Harbor Junction Br. #131

Elmwood Avenue, I-95 Underpass to Rogers Williams Park Entrance

NOTICE TO PROSPECTIVE BIDDERS

ADDENDUM NO. 3 Prospective bidders and all concerned are hereby notified of the following changes in the Plans, Specifications, Proposal and Distribution of Quantities for this contract. These changes shall be incorporated in the Plans, Specifications, Proposal and Distribution of Quantities, and shall become an integral part of the Contract Documents.

<p>LAMSON ENGINEERING CORPORATION Newton, Massachusetts</p>	<p>TITLE OF SKETCH RECONSTRUCTION OF HARBOR JUNCTION BRIDGE NO. 131 DRAINAGE AND UTILITY PLAN</p>	<p>R.I. CONTRACT NO. 2015-CB-045</p>
		<p>SKETCH NO. 3</p>
<p>DATE: 1/28/2016</p>	<p>ADDENDUM NUMBER 3</p>	<p>SHEET NO. 37</p>

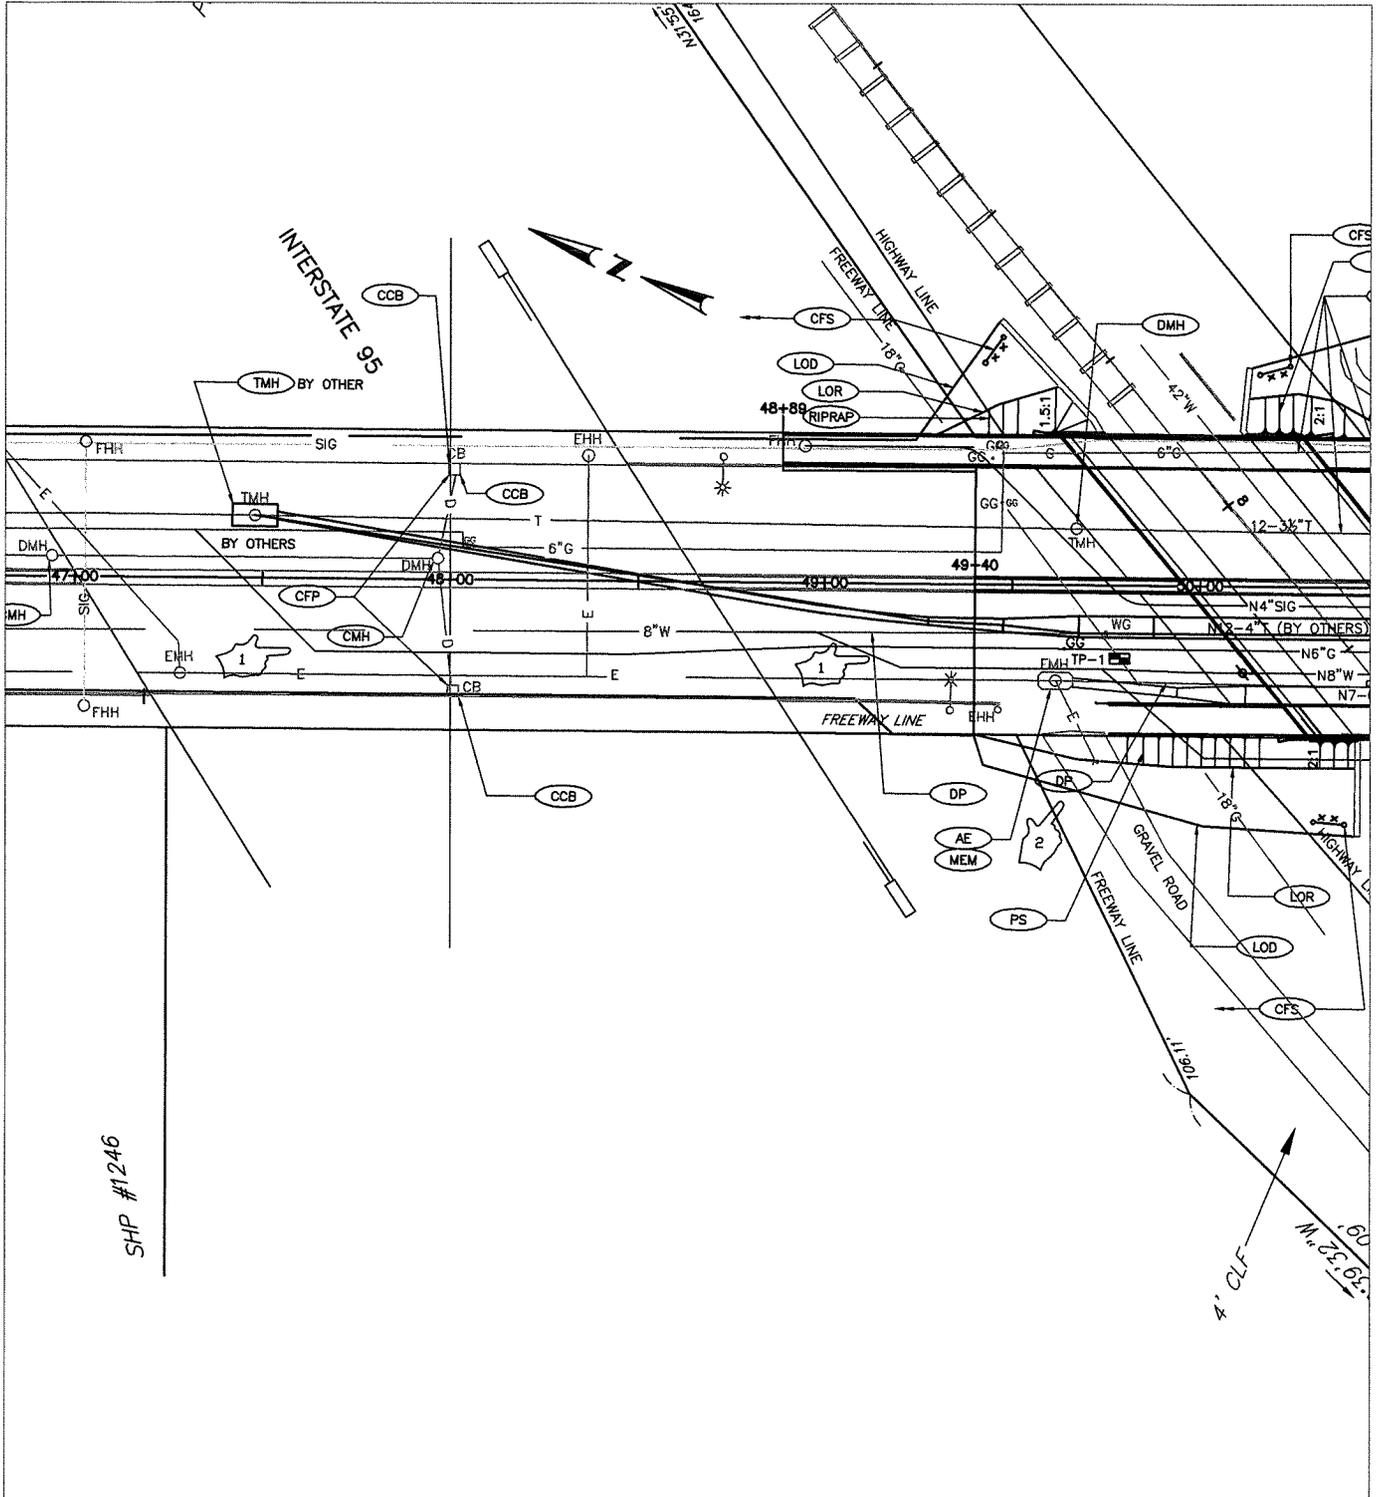
3. Sheet No. 37 – Drainage and Utility Plan

Revise Sheet No. 37 as shown on Sketch No. 3(R-2) attached to this Addendum No. 2. DP bubble with arrow has been added to the electric duct.
